# CITY OF ALBUQUERQUE

**RE: 3535 Menaul Blvd NE**  
**Grading and Drainage Plan**  
**Engineer's Stamp Date: 11/18/2025**  
**Hydrology File: H16D083F5**  
**Case # HYDR-2025-00432**

Based upon the information provided in your submittal received 12/03/2025, the Grading & Drainage Plan is **not** approved for Building Permit. The following comments need to be addressed for approval of the above referenced project:

GRADING AND DRAINAGE PLAN  
**C05.0**

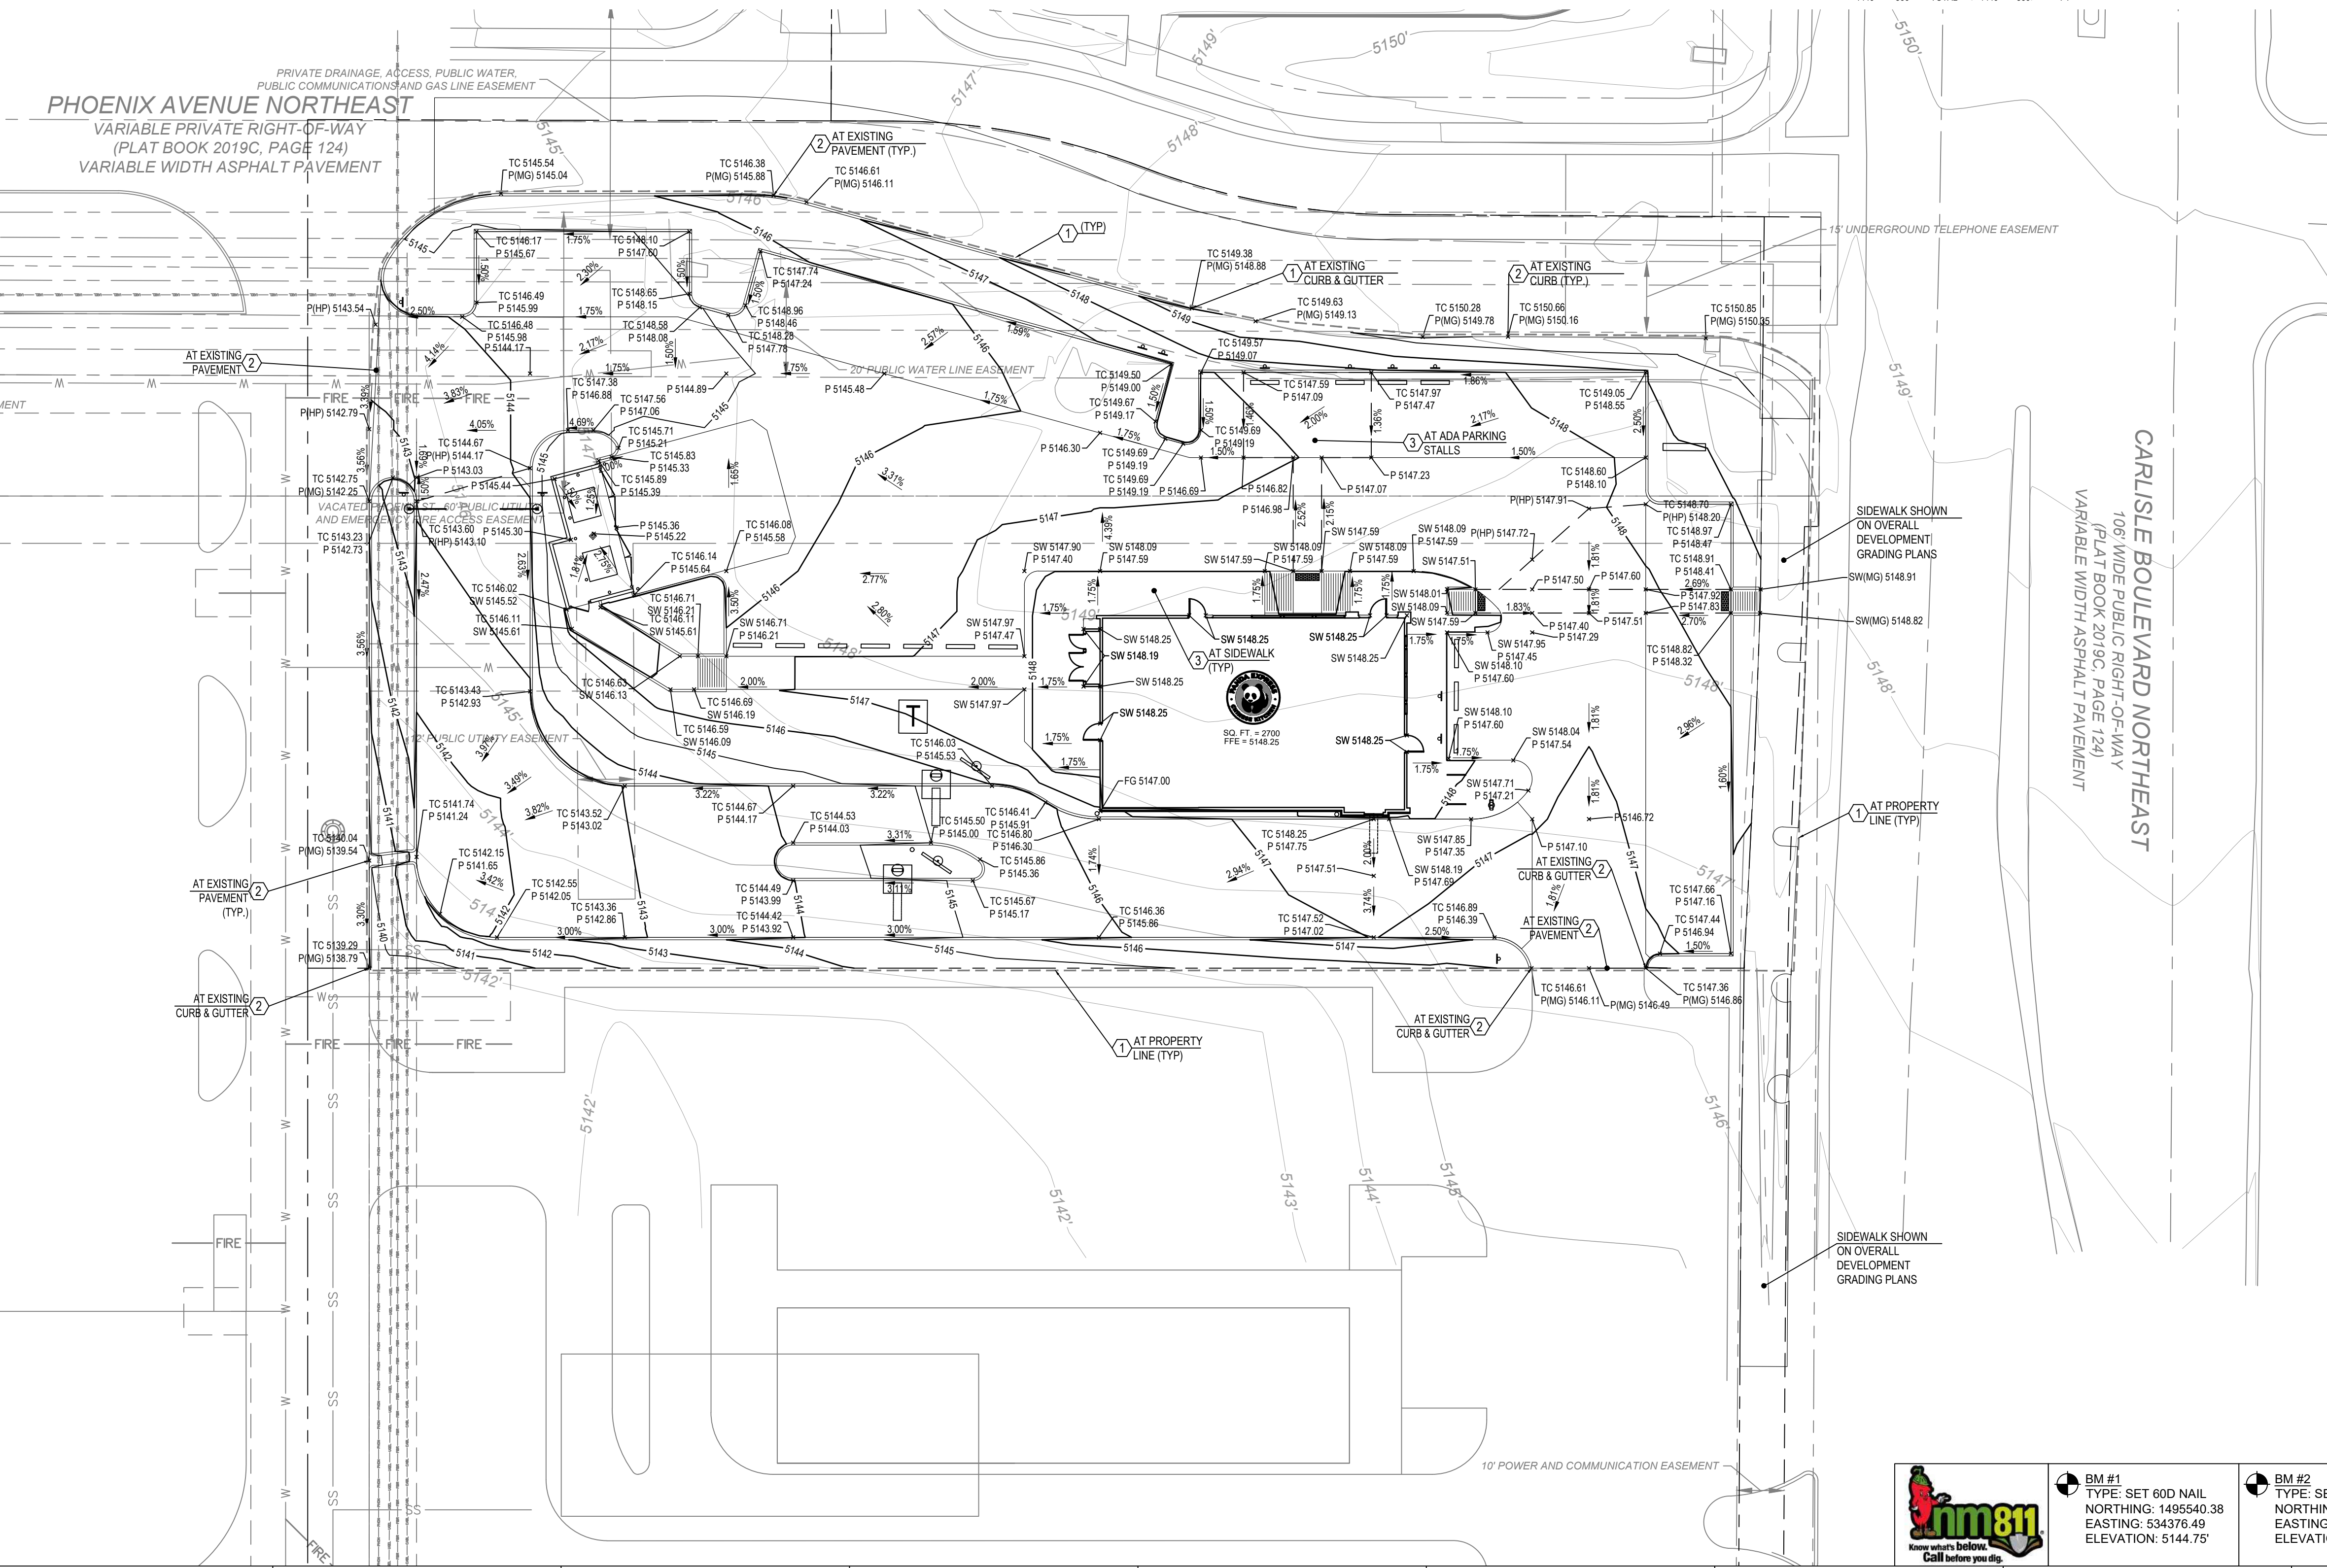
1. There is a reference to Sheet C01.1 for Grading Notes but this sheet was not provided. Please add the sheet or remove the note.
2. Show the Finished Pad elevation in addition to the Finished Floor elevation.

3. Show the direction of the roof runoff.
4. For trash enclosures serving food service developments, trash enclosures must demonstrate control of liquids from dumpster areas per DPM by containing runoff from the dumpster area, preventing outside drainage from entering the dumpster area, and discharging to the sanitary sewer. Please show an inlet in the middle and label. "Inlet to be connected to the sanitary sewer. See Utility Plan."

5. Please provide the FIRM Map on the plan.
6. Please show the calculations of both the required and the provided storm water quality volume on the Grading and Drainage Plan.

7. Please add a note which states, "The Owner has elected to pay the Payment in Lieu for the required Stormwater Quality Volume."
8. Show the calculation for the Payment in Lieu amount on the plan: (Amount = 956.6CF x \$8/CF = \$7,652.80).

9. Please submit the SWQV Waiver Application to Hydrology for review and approval.
10. Complete the Payment-In-Lieu and provide Hydrology with a copy of the receipt.
